W3F1-2004-0043

SUBJECT: Supplement to Amendment Request NPF-38-249,
Extended Power Uprate
Waterford Steam Electric Station, Unit 3
Docket No. 50-382
License No. NPF-38

**Response to Request for Additional Information
Related to the Extended Power Uprate**

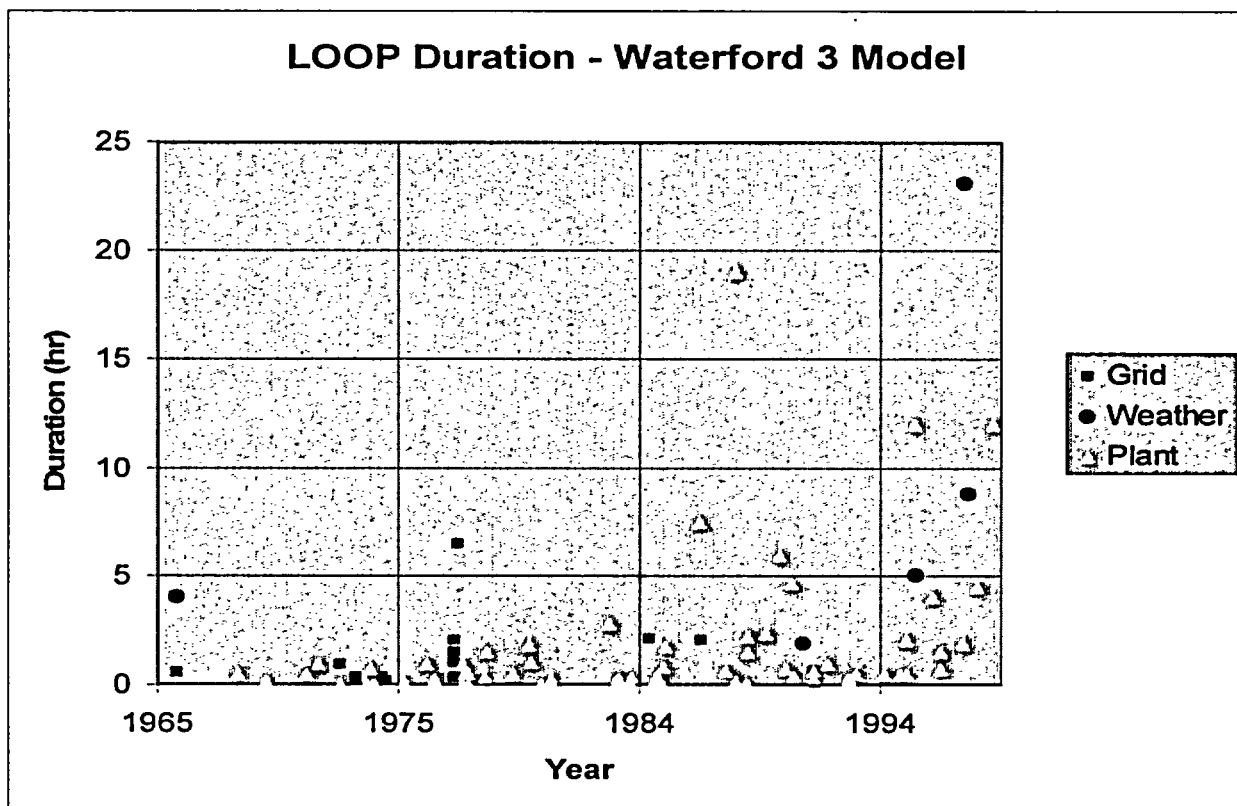
Page 2.11-2, Loss-of-Offsite Power (LOOP): Please provide the overall LOOP frequency, along with its constituent parts (plant-centered, grid-related, and weather-related frequencies). Describe the basis for estimating the LOOP frequencies and offsite power (OSP) recovery curves, identifying the methodology and data sources used. Justify that the data used is relevant to the Waterford post-extended power uprate (EPU) grid environment.

(Staff comment: NUREG-1784 indicates that since 1997 (when deregulation of the nation's electrical grid commenced), the nationwide plant-centered LOOP frequency has decreased, the grid-related and weather-related LOOP frequencies have remained constant, and OSP recovery times have increased. Since mixing older data with newer data tends to smooth out (de-emphasize) these trends, the post-EPU PRA results may not reasonably portray the post-EPU plant risk.)

The offsite power (OSP) recovery curves were developed using durations from the LOOP events used for the LOOP frequency, with the addition of LOOP events going back to 1965 [NSAC-85 (LOOP data through 1984), NSAC-166 (LOOP data through 1989)]. The OSP recovery curve was formed from a weighted mixture of Weibull probability distribution functions:

$$\Pr\{\text{OSP not recovered by time } t\} = G(t) = p_1G_1(t) + p_2G_2(t) + p_3G_3(t)$$

The following figure shows the duration of LOOP events used in the Waterford 3 OSP curve, separated by type and as function of time. This data goes through the end of 1999. The grid event durations show no discernible trend. Although the weather events are longer at later times, there are too few events (5) to draw conclusions about trends. (Recall that hurricane events are not included here.) In addition, there is no reason to assume that these few data points represent a trend of lengthening durations rather than simply reflecting the randomness

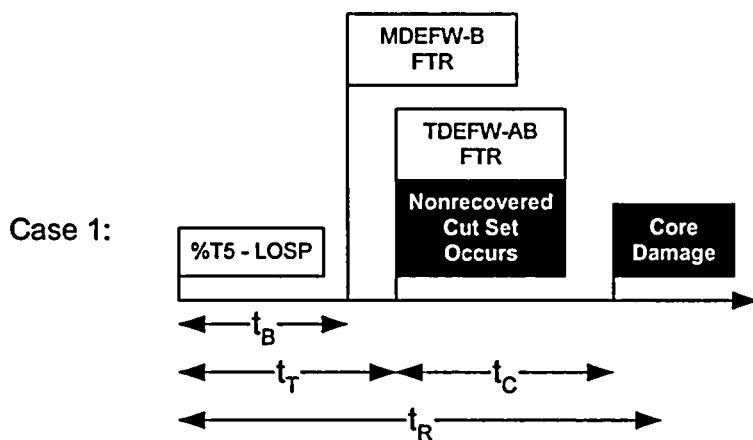
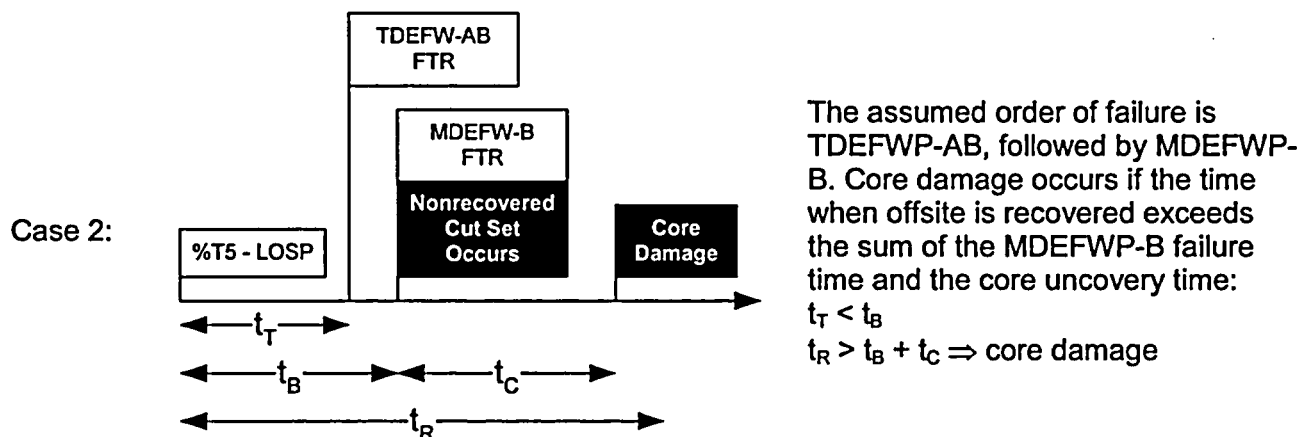
Page 2.11-7, LOOP Recovery: Please provide additional details about the convolution approach used to conduct the LOOP recovery analysis. Using the internal events post-EPU PRA model, conduct a sensitivity analysis to assess the impact of the convolution approach on the results by determining the CDF before any LOOP recoveries are considered.

The LOOP convolution recovery process is used to model recovery of offsite power (OSP). OSP recovery actions are modeled by adding OSP non-recovery events to the LOOP-initiated cut sets, automatically (using the QRecover software) according to pre-defined rules.

The assumed order of failure is MDEFWP-B, followed by TDEFWP-AB. Core damage occurs if the time when offsite is recovered exceeds the sum of the TDEFWP failure time and the core uncovery time:
 $t_B < t_T$
 $t_R > t_T + t_C \Rightarrow$ core damage

In these time lines, %T5 = LOOP initiator, TDEFW-AB FTR = turbine-driven EFW pump fails to run, and MDEFW-B FTR = motor-driven EFW pump B fails to run.

Quantification of the convolution integral requires specification of the integration limits. However, since there are two possible ways of ordering the timing of the Type-2 events in this example, this quantification requires separate assessment of each ordered case. The two ordered cases are as follows:
